Addendum 02

Date: March 31, 2025

STOCKTON UNIFIED SCHOOL DISTRICT

Expanded Learning Opportunities Program (ELOP) - Relocatable Classroom Buildings

JOB NUMBER:
23-12907.00
DWG. DATE:
03/06/25
AD2-ROO-
A110

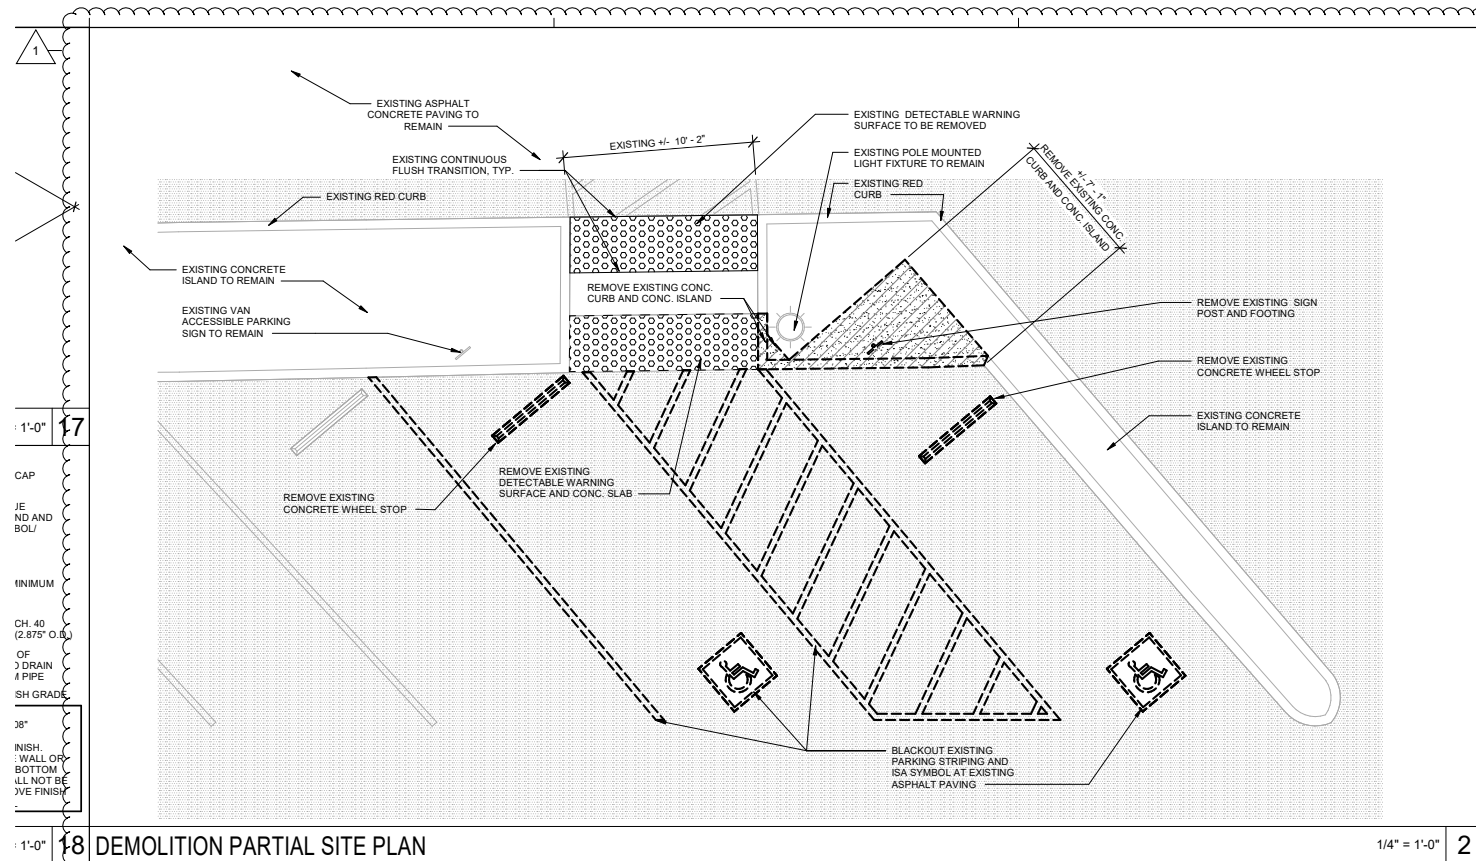
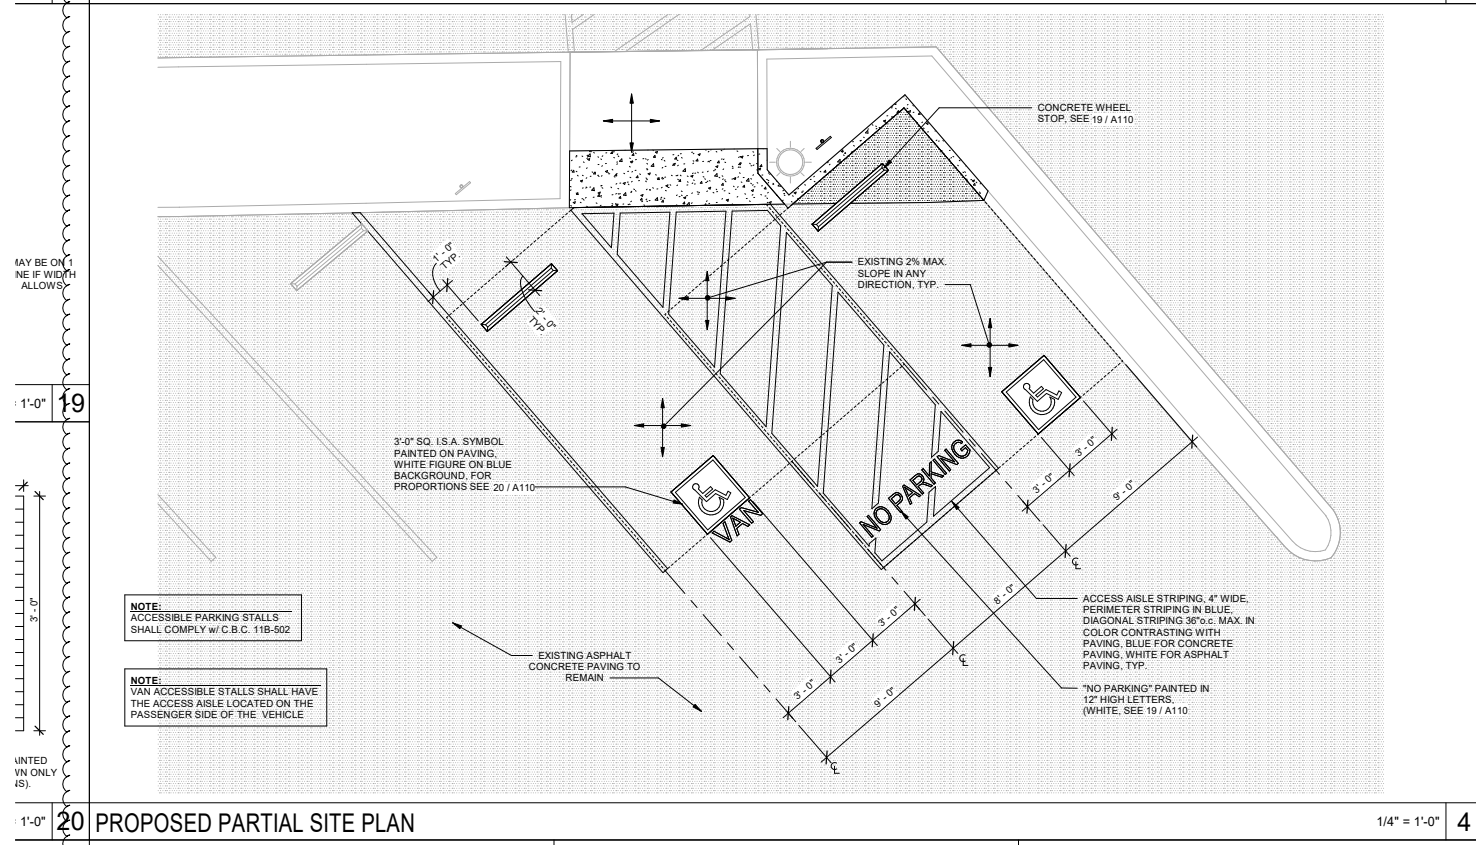
DRAWINGS:**2 - 014: DRAWINGS, SHEET A110, revise as follows:**

- A. Drawings 2 and 4 have been revised to show removal of truncated domes at accessible path. See provided exhibit, **AD2-ROO-A110**.
